Technical Evaluation Report

Draft Basis for Section 3116 Determination for Closure of the Calcined Solids Storage Facility at the Idaho National Laboratory Site

Final Report

U.S. Nuclear Regulatory Commission
Office of Nuclear Material Safety and Safeguards
Washington, DC 20555-0001

Figure 3-2: Bulk Retrieval System Installed on a Bin Set with Vacuum Line Extending Down to the Fluidizing Air Nozzle at the Bottom of the Bin (ICP, 2020)

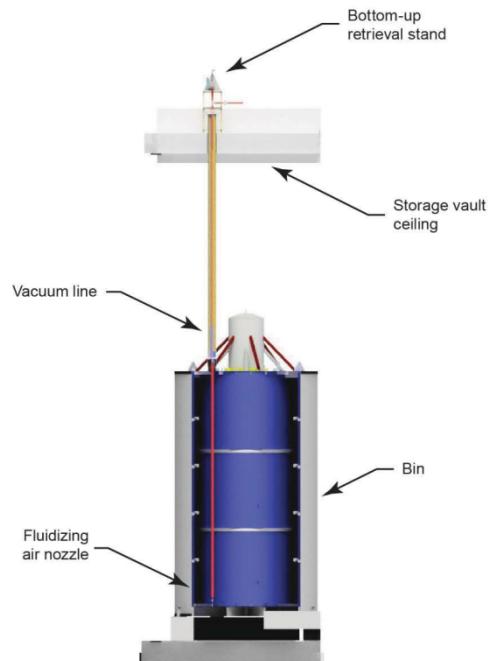
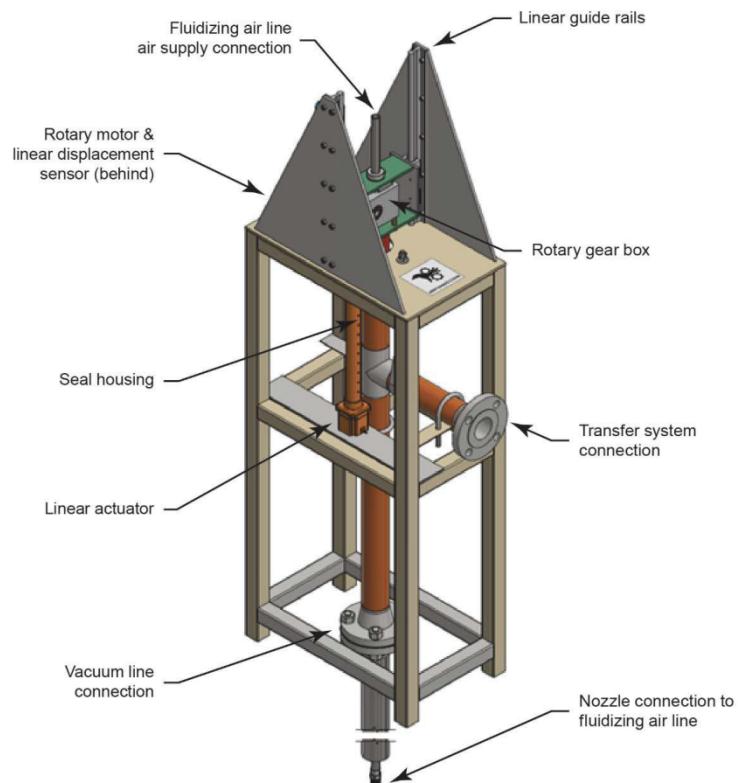
In its RAI MEP-1, NRC staff stated that insufficient detail has been provided as to the specific iteration of the pneumatic bulk retrieval system that will be employed (NRC, 2024). DOE incorporated multiple references to the WD that presented results of historical and full-scale mockup testing of the current iteration of the bulk retrieval system. However, these reports cited multiple areas of future work and did not provide reasonable assurance that DOE has developed the appropriate technology, to date, to complete this work. In response to NRC's RAI MEP-1, DOE noted that retrieval tests at the full-scale mockup are ongoing and that additional tests, equipment improvements, and operational retrieval sequencing continue to be optimized based on previous retrieval tests. NRC staff understands that the bulk retrieval system that will be employed to transfer calcine from CSSF 1 to CSSF 6 has not yet been determined and that DOE will continue iterating the system to enhance performance.

NRC staff recognize that testing of the existing system has been successful in achieving the 5.1 cm [2 in] residual calcine simulant height assumed in the CSSF PA. Additionally, in Section 5.1.3 of the WD, DOE has committed to optimizing retrieval designs and operations to achieve removal of HRRs to the maximum extent practical. Evaluation of the full-scale mockup testing and DOE's ability to remove calcine to the maximum extent practical, as required by NDAA Section 3116 Criterion (2), is discussed further in Section 3.4.1 of this TER.

Figure 3-4: Calcined Solids Storage Facility 1 Nested Bin Configuration

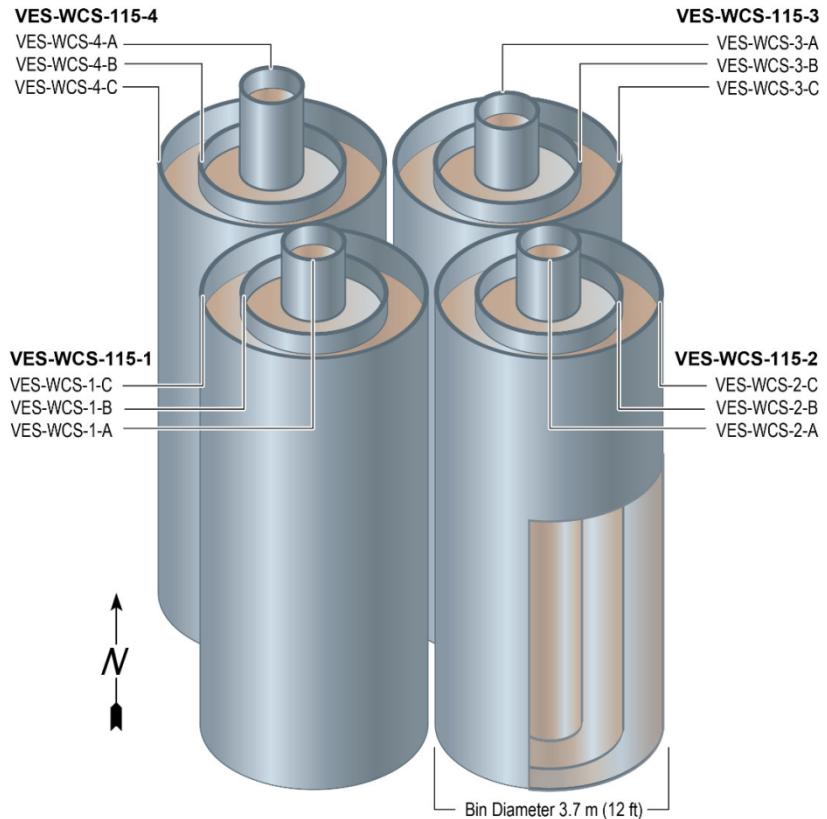
As compared to the geometry of CSSF 2 through 6, NRC agrees that CSSF 1's cylindrical and annular bin configuration as well as the multiple internal obstructions present the most challenging environment for physical manipulation of the bulk retrieval system. The full-scale mockup of CSSF 1 demonstrates a realistic physical geometry and presents additional opportunities for testing of the installation of access risers to the bin sets. When accounting for elevation change and additional gravitational impact of calcine retrieval at greater depths in other CSSF bin sets, DOE should continue to monitor pressure boundaries and adjust the piping system parameters and location within the bin to achieve sufficient agitation and suction when removing calcine.

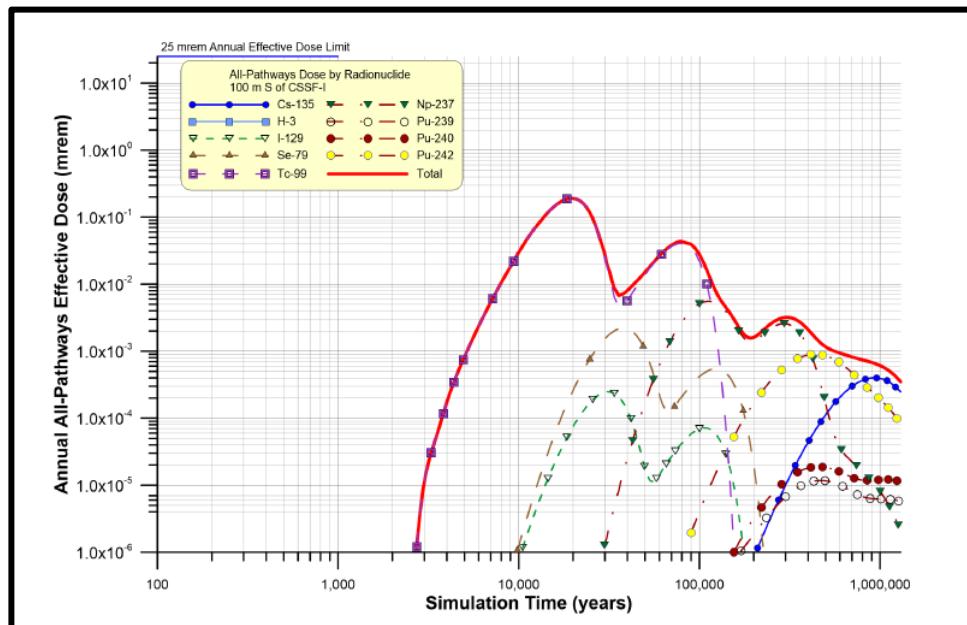
DOE presented results for the base case in the PA (DOE-ID, 2022). The simulations were updated following NRC staff's requests for additional information to change the thickness of the CSSF 1 vault to 0.6 m [2 ft] instead of 1.5 m [5 ft], and to change the Np-237 K_d from 500 L/kg to 100 L/kg. Three groups of radionuclides are simulated using the Mixing Cell Model computer code used for the near-field modeling, which only allows 10 radionuclides to be run at a time.

Figure 4-3: Groundwater Annual All-pathways Effective Dose for the Base Case and Original OFAT Cases 1-5. Image Credit: Figure 6-6 in DOE-ID (2022).

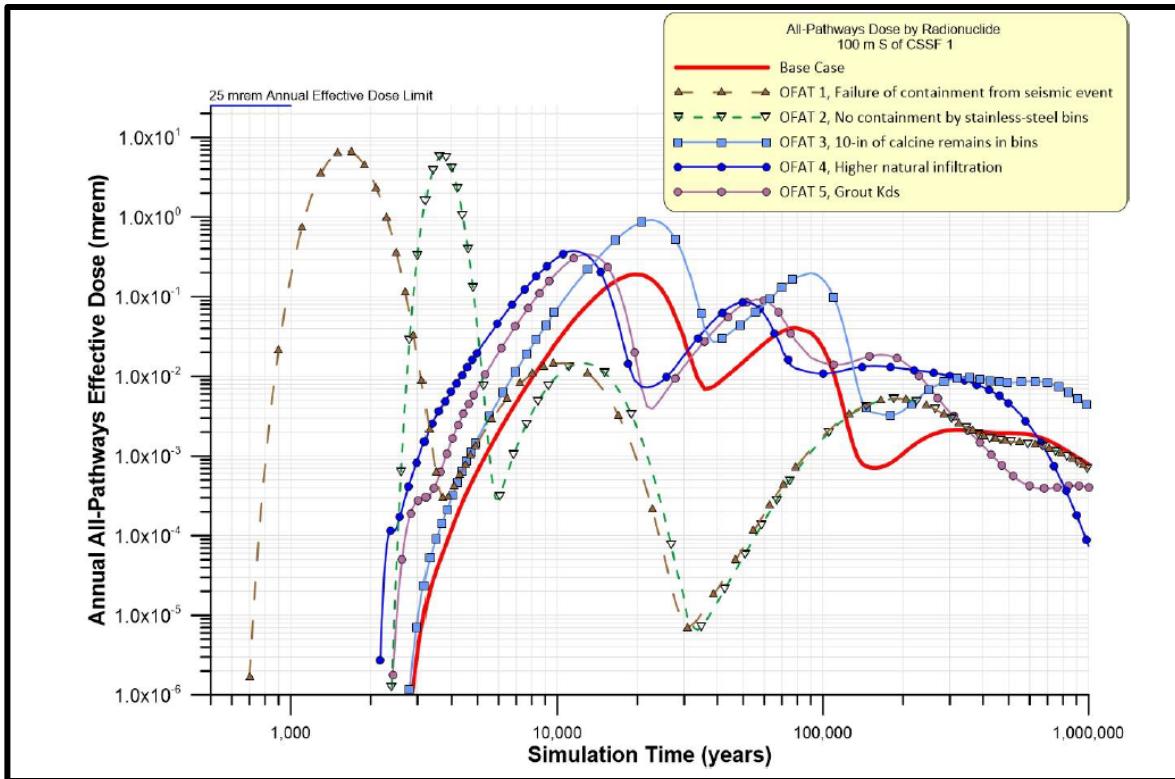
While the OFATs were re-run with the thinner CSSF concrete base and lower Np-237 K_d , Figure 6-6 in DOE-ID (2022) was not reproduced with the updated results. Figure 4-3 below shows the PA results in DOE-ID (2022), which may not exactly match the results in Table 4-4 with the updated parameters. However, minor changes in the peak doses resulted from the updates to the parameter values due to the dominant radionuclide being long-lived and mobile Tc-99. In some cases (e.g., re-run of OFAT 2), the dose was even a little lower due to less overlap of the CSSF 1 and CSSF 2 doses with the decrease in CSSF 1 concrete base thickness.

As can be seen in Figure 4-3, even with the SS bins and grout assumed to be failed between 500-600 years, the release of Tc-99 (a nearly conservative species with limited to no sorption) takes hundreds of years to be released from the engineered system and to travel through the vadose zone (approximately 500 years). As discussed in more detail in Section 4.2.5, assuming the waste is not mixed in with the grout (i.e., the waste is assumed to be a discrete layer at the bottom of the bin sets), and assuming more discrete failure of the engineered system (i.e., higher steel bin failure rates) could lead to a significantly higher dose.

Figure 4-4: DOE's Probabilistic All Pathways Effective Dose Results for CSSF 1 Receptor. Image Credit: Figure 6-7 (DOE-ID, 2022).

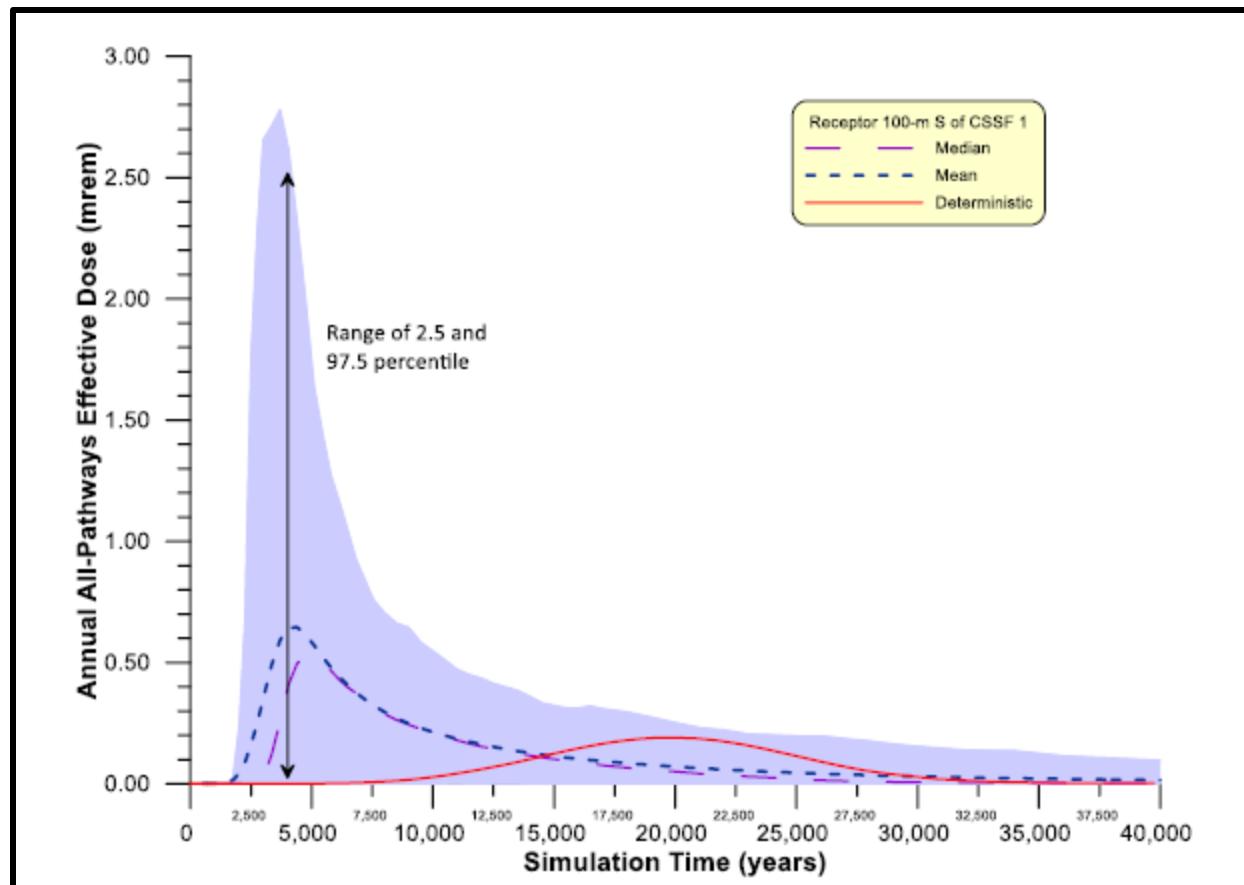
Parameter distributions are listed in Table 6-3 of the PA (DOE-ID, 2022). The results of the uncertainty analysis are provided in Figure 4-4. DOE did not update the probabilistic analysis in response to RAIs (addressed RAIs with OFATs). The timing of the peak dose in the PA is between 3,000 and 4,000 years (DOE-ID, 2022). To address NRC's RAI comment about the potential risk dilution, DOE indicated that the mean of the peak dose is less than a factor of two higher than the peak of the mean (DOE-ID, 2025a). Additionally, the deterministic dose {2 $\mu\text{Sv/yr}$ [0.2 mrem/yr]} occurs much later and is lower than the peak of the mean and 95th percentile of the probabilistic dose of 6.4 $\mu\text{Sv/yr}$ [0.64 mrem/yr] and 22.9 $\mu\text{Sv/yr}$ [2.29 mrem/yr], respectively. Based on Table 6-5 in the PA (DOE-ID, 2022) of the radionuclides studied (Se-79, Tc-99, Np-237, U-233, and Th-229), a significant portion of the dose is associated with Tc-99 followed by Np-237 and U-233, with the 97.5 percentile doses of Np-237 and U-233 still contributing orders of magnitude less than Tc-99.

The results of the analysis suggest bin lifetime is negatively correlated to dose, Tc-99 K_d in interbed and grout are negatively correlated to dose, and there is a positive correlation of Tc-99 inventory to dose. There is a strong positive correlation between geometric standard deviation (GSD) of bin failure times to dose. DOE explains on page 6-26 of the PA that the positive correlation for the annual all-pathways dose at 4,050 years shown in Figure 6-9 of the PA (DOE-ID, 2022) is due to the greater likelihood of a release occurring at earlier times with a greater GSD, although peak releases will be smaller.

Figure 4-5: (a) Water Fluxes Through the Grouted Waste Layer as a Function of Time; Reproduced from Figure 5-1 in DOE-ID (2022). (b) CDF of the Corrosion Failure Times, Assuming Corrosion Rates Follow a log-normal Distribution.

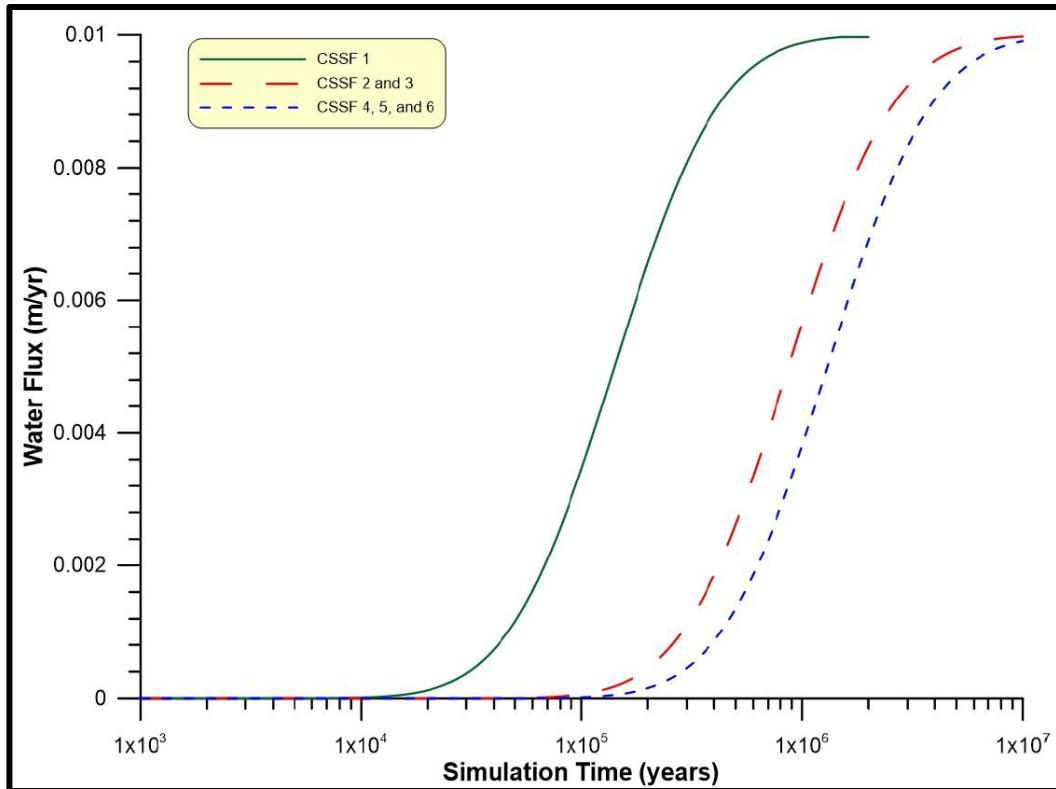
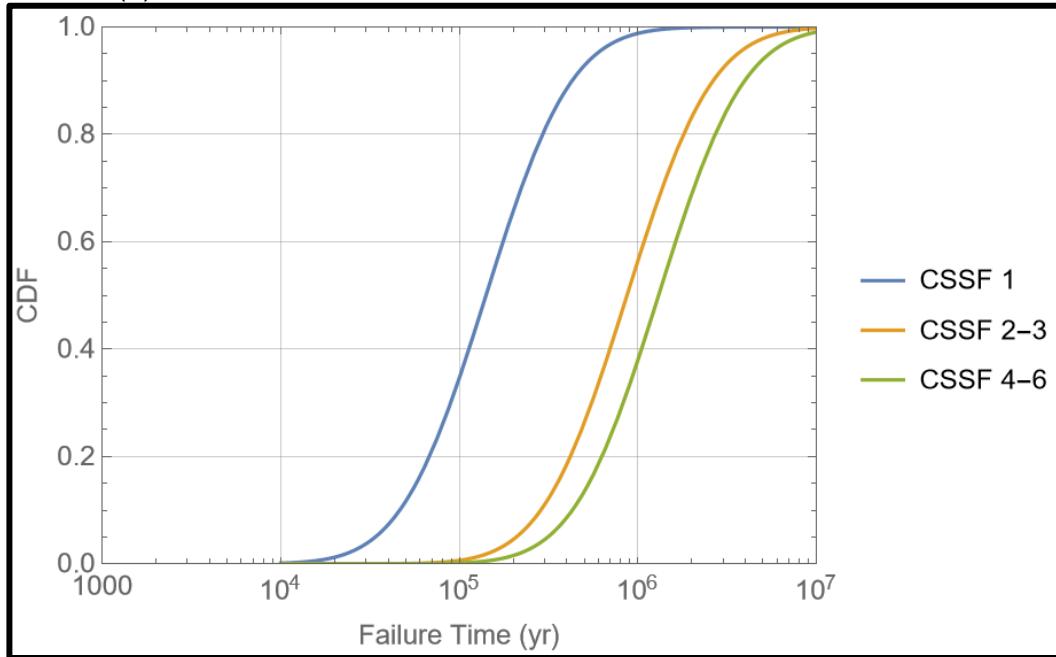
Figure 4-5 compares the water fluxes and the failure time CDF. Figure 4-5(a) reproduces Figure 5-1 of DOE-ID (2022); the plot represents the water flux through grout versus time, computed considering two factors previously described. The Figure 4-5(b) is the failure time CDF computed assuming corrosion rates follow log-normal distributions. The curve shapes demonstrate that the bin failure time CDF factor is dominant to determine the water flux versus time.

NRC staff requested additional information to support DOE's assumed SS corrosion rates and modeling approach (NRC, 2024). The corrosion rates of the Base Case assumed to apply to long time frames after removal of the calcine and after grouting were based on data collected from corrosion coupons exposed to natural and unprotected soil over a 12-year period (Adler-Flitton et al., 2011). Because of the arid climate, the natural soil is expected to be relatively dry and not promote corrosion. In fact, many SS test 304L coupons did not exhibit measurable corrosion over the 12-year period (Adler-Flitton et al., 2011). Non-zero corrosion rates were only detected in a few coupons. These non-zero corrosion rates are summarized in 14 data points in Table 4-5 of DOE/ID-12008 (DOE-ID, 2022) that were used to develop a distribution of corrosion rates for the PA model. DOE's estimated corrosion rates were on the order of a few nanometers per year, that are consistent with passive corrosion rates. NRC requested additional information to support the approach used to calculate corrosion rates following closure (i.e., SS in contact with grout), including an evaluation of alternative mechanisms that could lead to higher corrosion rates (e.g., crevice corrosion, pitting corrosion, galvanic corrosion). Additionally, NRC staff had technical issues with the conceptual model that assumed the fraction of the bin area that is breached directly controls the fraction of flow through the engineered system mobilizing the radioactive waste (e.g., 100 percent of the bin area would have to be breached to allow 100 percent of the background 1 cm/yr [0.4 in/yr] infiltration rate to flow through the waste zone). This conceptual model is discussed further in the "Waste Release Modeling" and "Uncertainty Analysis" sections below.

In its RAI, NRC staff stated that the soil exposure testing was not designed to represent a set of conditions that would unequivocally "bound" corrosion in pristine or degraded grout, including corrosion in crevices that might accumulate chemicals promoting localized corrosion. Corrosion rates in the literature for SS/grout systems, for example measured with electrochemical methods using aqueous solutions, are commonly higher than the nanometer per year corrosion rates measured in 12-year soil exposure using weight loss experiments.

Figure 4-8: CDF of Updated CSSF 1 Analysis Using Corrosion Rates in Contact with Calcine Compared to Base Case Corrosion Rates Based on Passive Soil Conditions

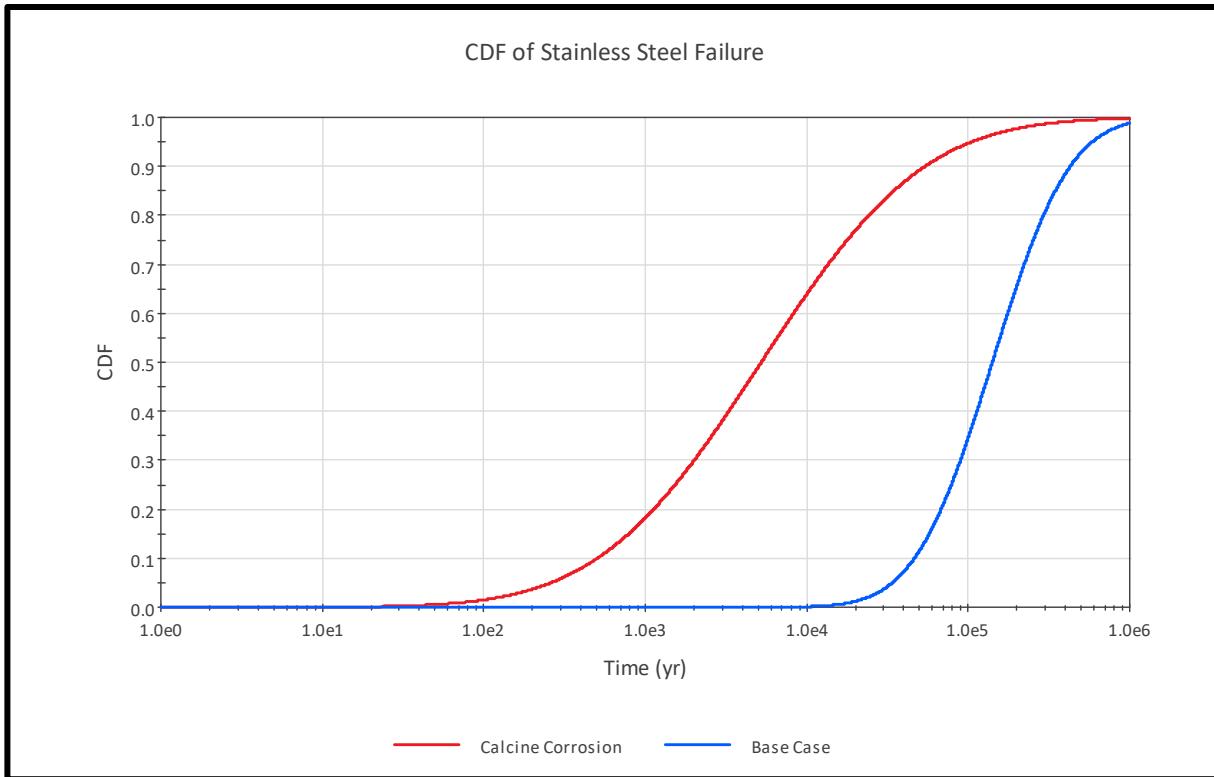
Additionally, NRC staff indicated that alternative conceptualizations involving common cause failures may be more realistic than assumed in the PA and could lead to more rapid failure affecting multiple barriers (e.g., lack of mixing of waste with grout coupled with lower retention of waste in grout; preferential flow of water along steel bin walls and through the waste zone leading to enhanced corrosion and higher release rates; earlier steel bin failure; and greater infiltration rates through the engineered system). Therefore, in response to RAI PA-6, DOE included an additional MFAT to address NRC comments regarding multiple barrier failure. DOE indicated that this barrier analysis considered pessimistic assumptions concerning the (1) lifetime of the SS bins, and (2) lifetime of the grout, (3) K_d s in cementitious materials and natural system, and (4) natural infiltration rates. The CDF used for the MFAT analysis was based on the OFAT 7 analysis with higher corrosion rates for SS in contact with calcine. The peak dose was a factor of 58 higher compared to the peak dose from the Base Case (0.11 mSv/yr versus $1.2 \times 10^{-3} \text{ mSv/yr}$); however, the doses were still not as high as OFAT 1c with notable differences being even faster corrosion and fracture flow through the system, as well as higher infiltration rates and more pessimistic sorption coefficients. The MFAT did show more significant doses from Np-237, Pu-239, Pu-240, and Pu-242 (see Table 68 and Figure 86 in the PA). Therefore, NRC staff determined that uncertainty in the sorption coefficients for Pu should have also been included in the MFAT analysis considering that Pu exists in multiple oxidation states, and because experiments suggest a small percentage of highly mobile Pu species may be present in the oxidizing INL environment.

While DOE did not perform an updated probabilistic analysis, DOE performed a series of additional OFAT and MFAT analyses addressing potential technical issues enumerated in NRC staff's PA RAI-6. The results of the additional analyses were all less than 0.25 mSv/yr. Therefore, NRC staff have reasonable assurance that the 10 CFR 61.41 performance objective can be met provided key assumptions in DOE's PA are met.

Figure 4-11: Revised Map of Figure 2-43 in DOE-ID (2022) and Figure 2-44 in DOE (2023). Image Credit: Figure 98 in DOE-ID (2025a).

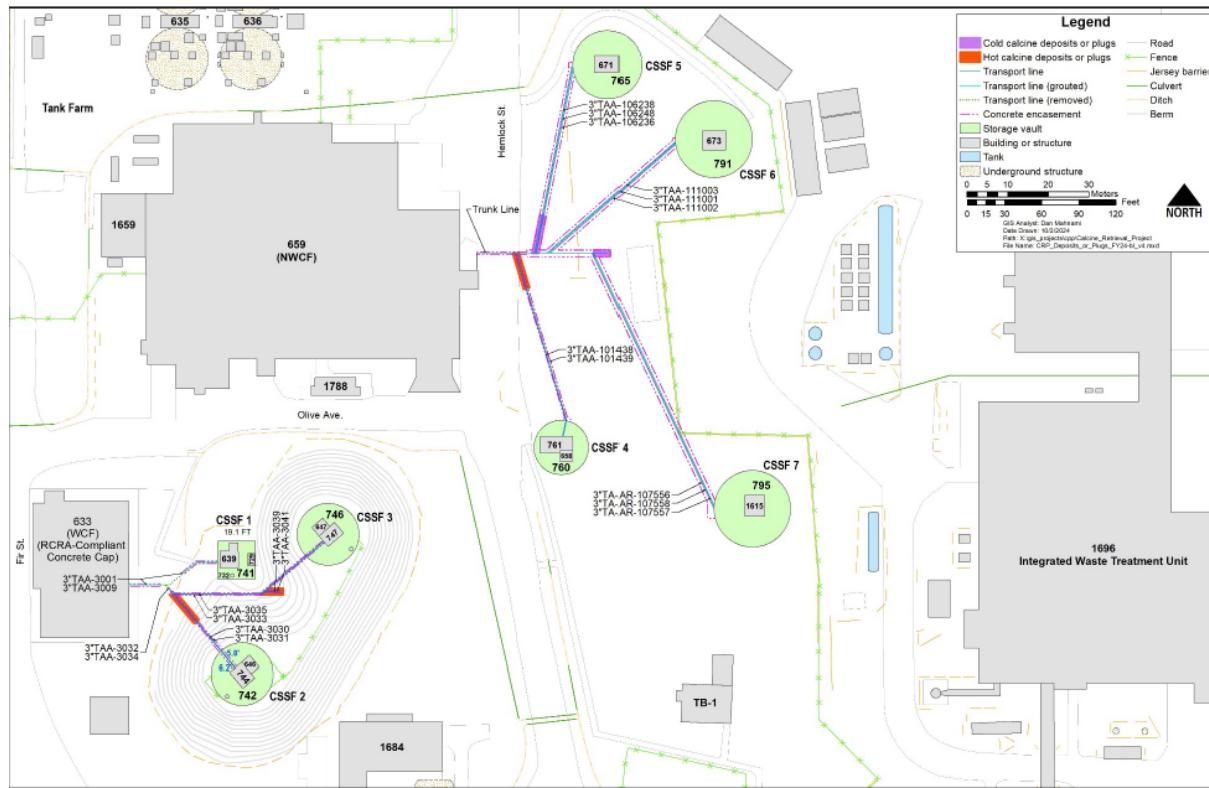
NRC staff also requested additional information regarding the potential for accumulation of waste in the transport lines, and clarify the basis for the potential accumulations depicted in Figure 2-42 of the PA (DOE-ID, 2022) and Figure 2-43 in the waste determination (DOE, 2023) reproduced below in Figure 4-11 (e.g., clarify if the accumulations were based on characterization data or process information alone).²⁸ NRC staff also questioned whether DOE had plans to characterize transport lines in the future to validate the assumed accumulation volumes and residual film volumes remaining in the transport lines.²⁹ In response to RAI PA-5 (DOE-ID, 2025a), DOE indicated that EDF-11119 (DOE-ID, 2018a) provides the most recent compilation of the current knowledge about the state of residual contamination in the transport lines. The air transport system sent cold material through the system and in other instances when operations switched to the next CSSF no cold material was sent through the system (e.g., between filling CSSF 2 and 3). Deposits developed in dead legs or in transport lines no longer in use (e.g., CSSF 2 solids transport line, the stub outs of CSSF 3 solids transport line, and possibly in the CSSF 4 transport lines when operations switched between 4 and 5). The rest of the transport lines were assumed to have a film of calcine residue 0.35 mm [0.014 in] on internal surfaces. There are currently no plans to sample the residual calcine in the transport lines in the future.
